HISTORIC REVIEW BOARD

AGENDA

Tuesday, September 11, 2018

Application Number: 18-80
Date: September 11, 2018
Address: 213 E Schubert
Zoning: R2
Owner: Ron Ross
Applicant: Eric Mustard, Mustard Design
Rating: Low
Proposal: Construction of new house

SITE PLAN

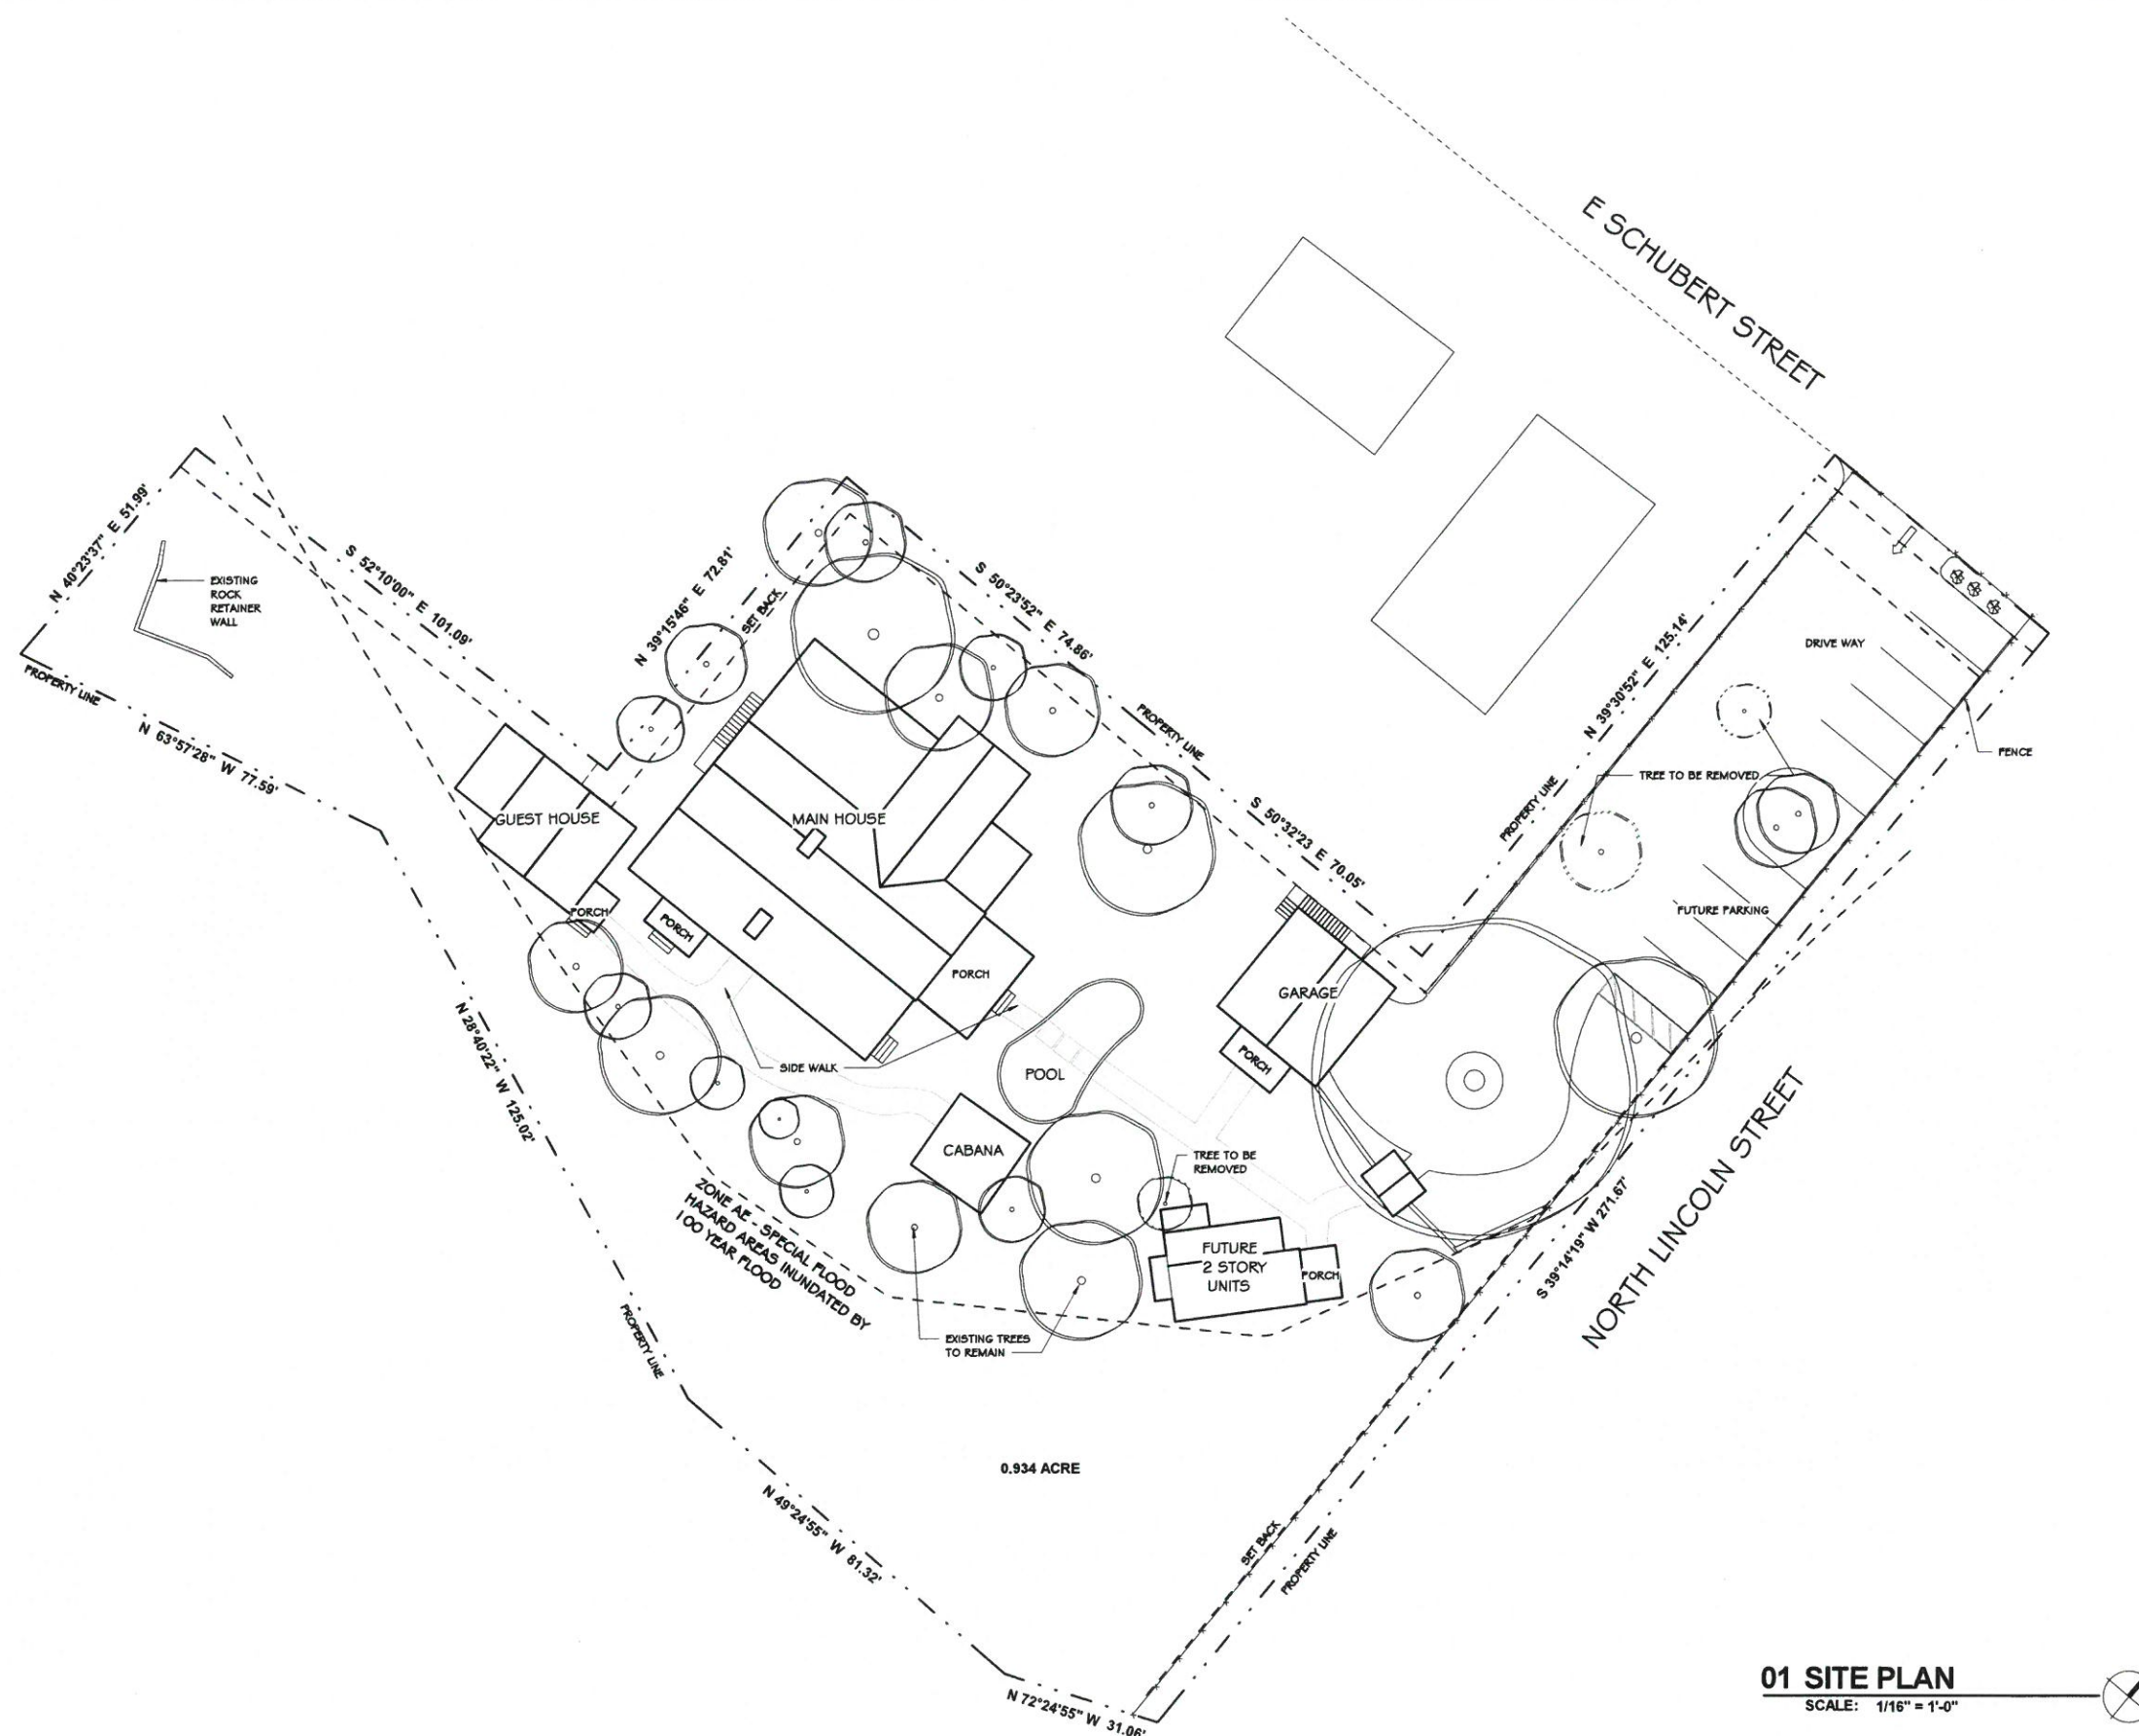
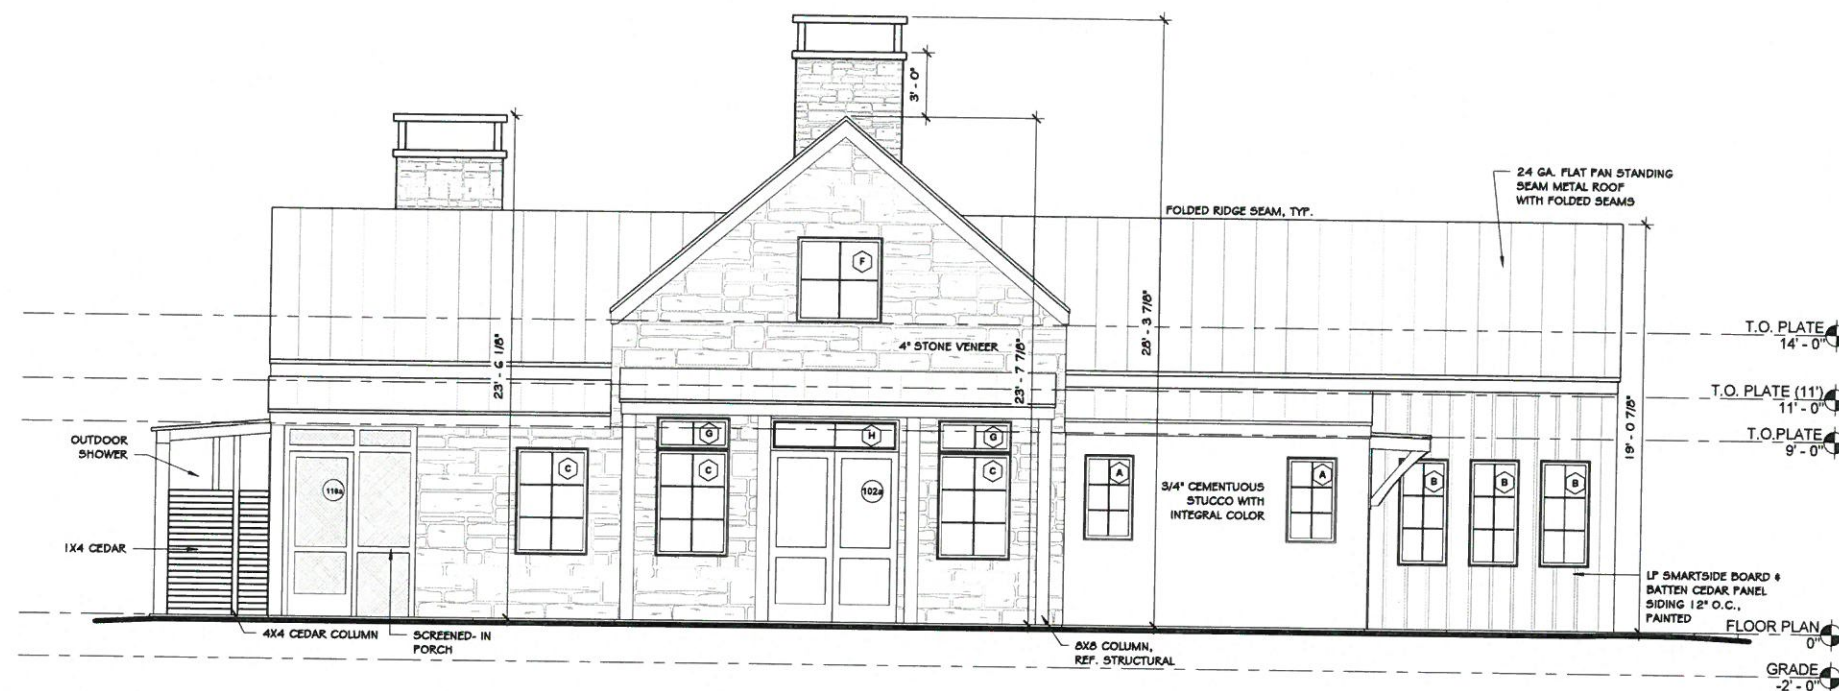
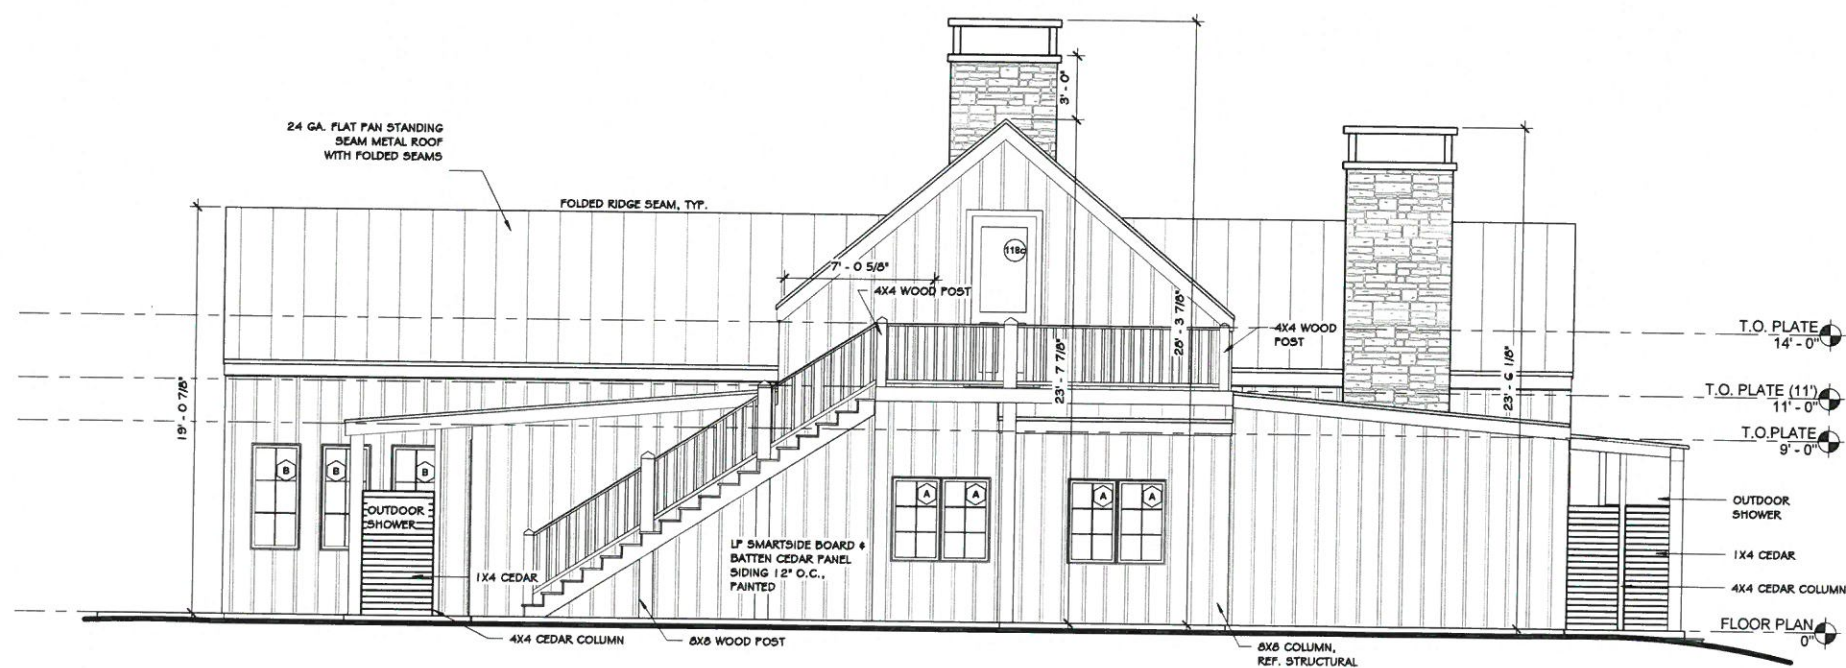
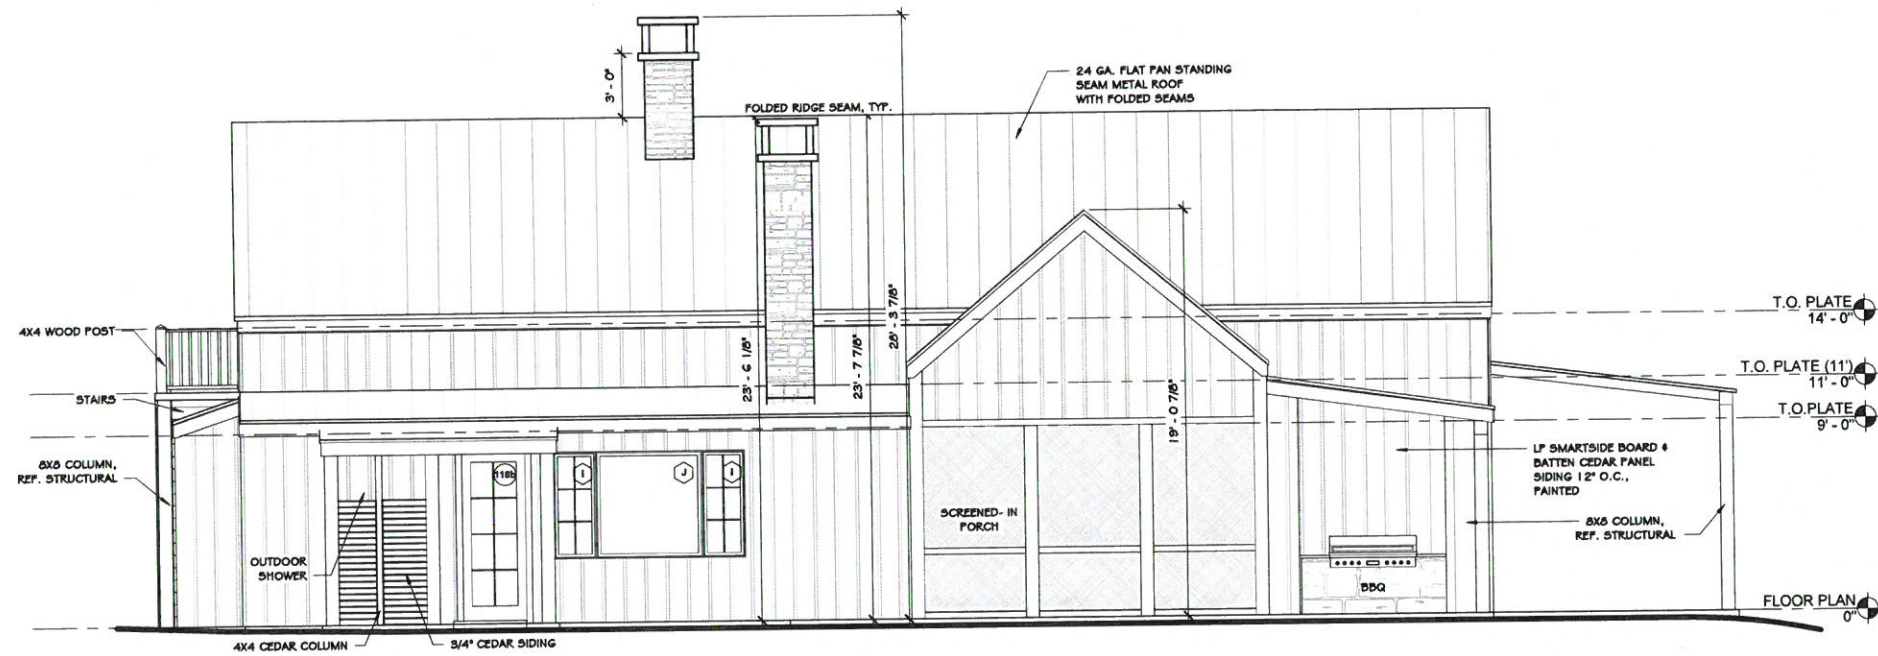
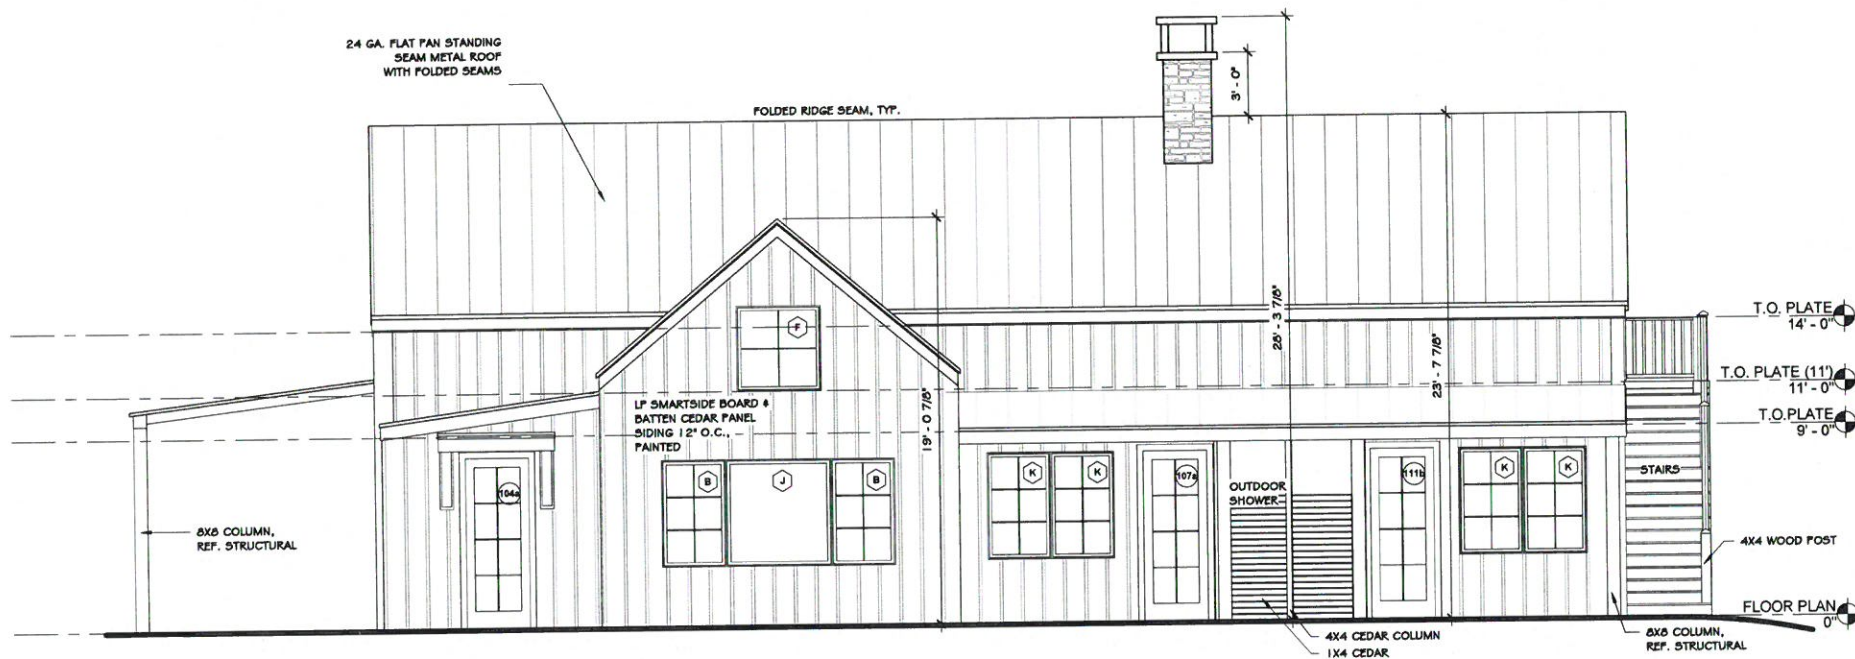
1. The HRB approved the demolition of a low rated structure that made way for new construction on this odd shaped lot that is not readily visible from E Schubert Street. The new house will be placed essentially in the same site as the previous house. The lot has significant tree coverage and floodplain restrictions. The design of the house could be considered traditional Hill Country style with rock veneer, stone, stucco and Hardi board and batten siding. The roof will be a traditional standing seam. The front of the house will have a front-facing gable. The size and location of the lot along with the significant floodplain issues do not allow the house to follow a traditional site and setback standard. The side of this house will be behind 209 and 211 E Schubert, though not readily visible. The style, materials, roof pitch, are appropriate for the historic district. Staff recommends

The applicant does not have drawings completed for the guest house and garage at this time, just the main house.

approval as submitted based on SOI #10 and FBG Design Guidelines for new construction and the fact that the house will not be readily visible from the street. The new construction will not have a negative impact on the historic district.

DRAWING:
ELEVATIONS
DRAWING SUB NAME
SCALE: 3/4" = 1'-0" DATE: #AUG, 2016

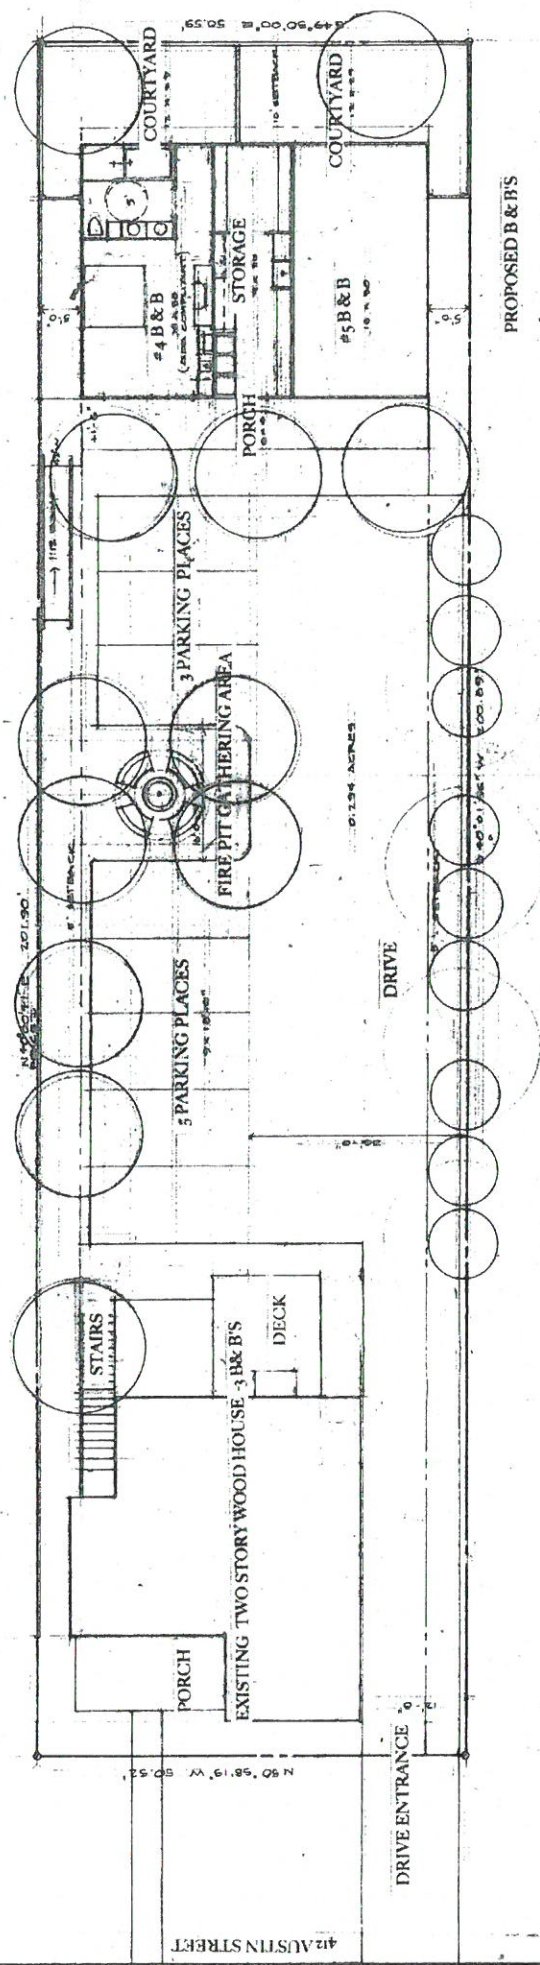
1. The house currently has a rear deck over a rear addition with a wooden stair with switchback. The applicant is requesting approval to relocate the stair to the other side of the porch. Staff recommends approval as submitted based on SOI #10 and FBG Design Guidelines for additions. The materials are appropriate and will not be visible from the street.

The owner has plans for new B&B units on the site plan, but does not have sufficient drawings to request approval at this time.

Per the request of the Historic Review Board, the proposed stairway replacing the current stairway will be constructed of treated pine for the main framing members (stringers) and treads, steel support posts, cedar rails and pickets to meet current code requirements. Cedar can be sealed with natural (clear) sealer or stained any color with an opaque stain.
